ADA Compliance Program

Clark County Facilities Transition Plan Clark County Juvenile Justice Center

Date of Survey: March 27, 2006
 Conducted by: Clark County Citizen ADA Advisory Board

Item: Drinking Fountain – 1st Floor Lobby – Protrusion Limits

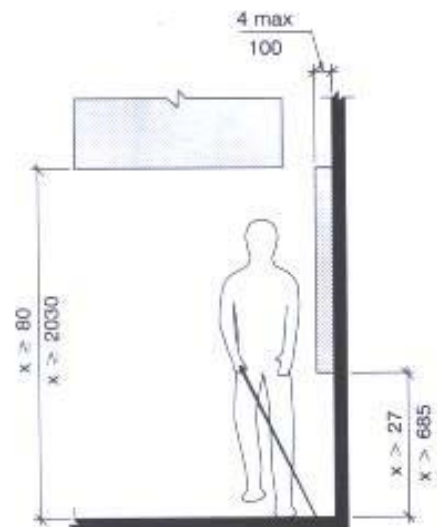
ANSI 307.2 Protrusion Limits. Objects with leading edges more than 27 inches and not more than 80 inches above the floor shall protrude 4 inches maximum horizontally into the circulation path. The drinking fountain shown protrudes 11 inches and the height shown is 32 3/8 inches.

The fountain should be recessed into an alcove.

Item: Telephone – 1st Floor Lobby –
Protrusion Limits

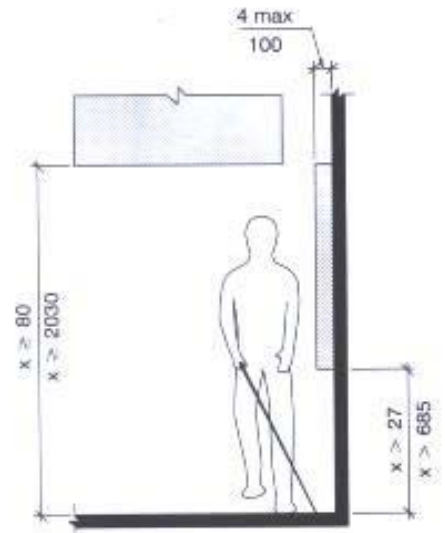
ANSI 307.2 Protrusion Limits. Objects with leading edges more than 27 inches and not more than 80 inches above the floor shall protrude 4 inches maximum horizontally into the circulation path. The drinking fountain shown protrudes 11 inches and the height shown is 32 3/8 inches.

The telephone should be recessed into an alcove.
